ROXUL, USA, INC – WVG611896 Multi-Sector Stormwater General Permit.

Date; October 23, 2019

To; Director, Division of Water and Management, DEP

INTERGRATED ENVIRONMNETAL PLAN, RAN 5 FACILITY - POND LINER SYSTEM DETAIL, SHEETS 1, & 2, DATED 05/09/2019

Water Pollution in the Arabian Plain impacts most of the county

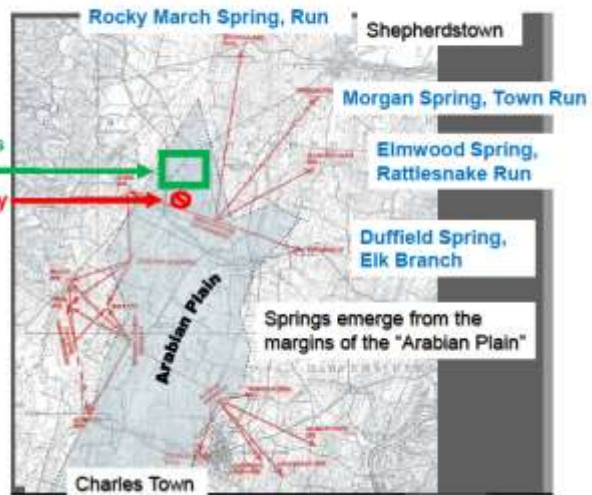
Highest density of sinkholes in the county
Proposed Rockwool Factory

Small red arrows rapid flow away from Arabian Plain to springs that feed our streams

Any chemical introduced into the groundwater near the Rockwool Factory will contaminate the water of the northern part of the county

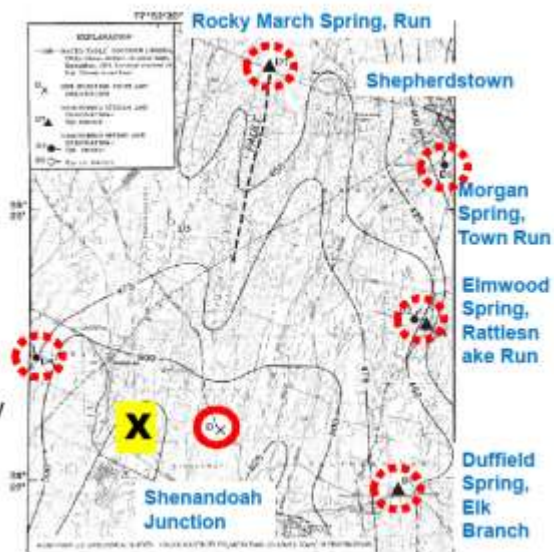
-  Injection point
-  Proposed Rockwell Factory
-  Dye detected weeks later

Detection 2 weeks later at Rocky Marsh and it takes 25 weeks to clear from all locations

The drawing below is titled **Potential Sinkhole Risk Map** and shows the location of the three lagoons. The drawing notes that the lagoons are located in a “**POTENTIAL SINKHOLE RISK**” area.

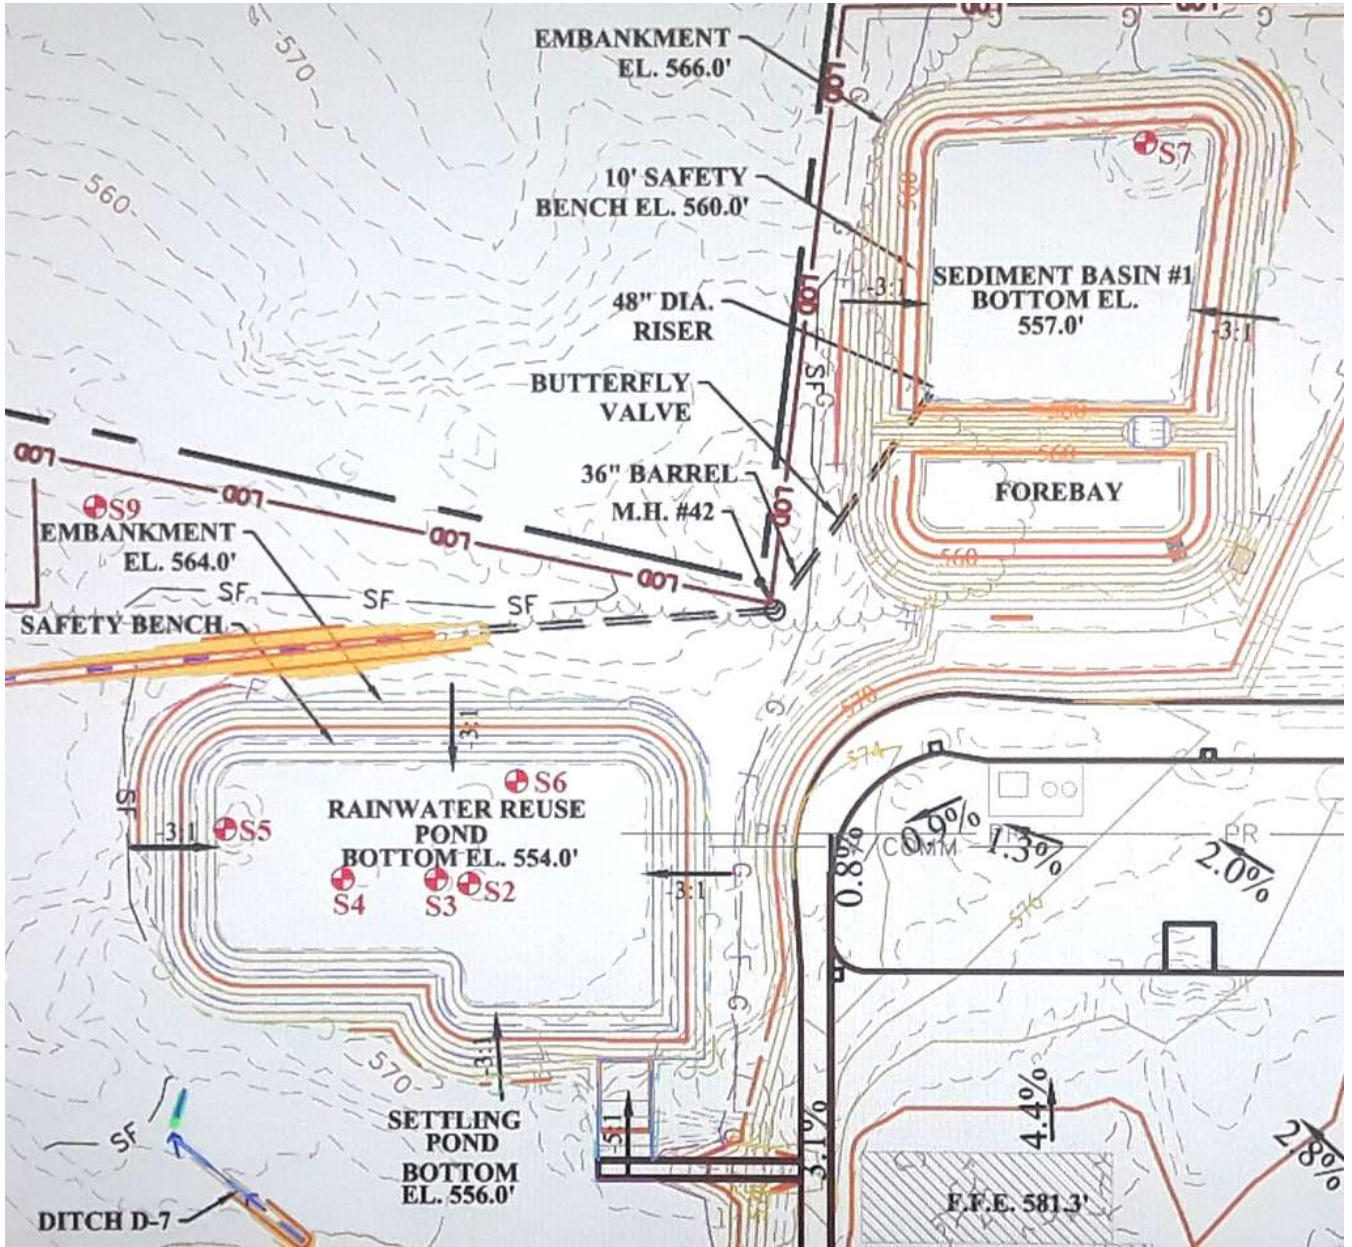
The greatest danger to the groundwater supply is from the sinkholes which have **NOT YET FORMED**. It is almost certain that sinkholes will form under the ponds. It is highly likely that the ponds liners will be damaged and the seams opened up due to the great stress placed on the liner and the liner joints from the weight of the liquid in the pond and the opening of the sinkhole below.

- According to recent Permit Application of 6/22/2019 and 7/22/2019, there are a total of **17 reported sinkholes within the site, including 5 in the Rainwater Reuse Pond, shown as S2 to S6 on the plan..** Some of the sinkholes are many feet in diameter and located in the ponds.
- The increase of **impervious surface** area due to roads, parking lots and buildings will produce a much greater rate and volume of runoff. **More runoff greatly increases the risk of new sinkhole formation.**
- It is **highly likely that more sinkholes will be formed**, caused by the excavation, blasting and pile driving required to construct the foundations of the smokestacks and the heavy equipment required to build the smokestacks.
- Rockwool drawings show the lagoons located in a “**potential sinkhole risk**” area. **The drawings do not show how the risk from sinkholes is to be mitigated.**
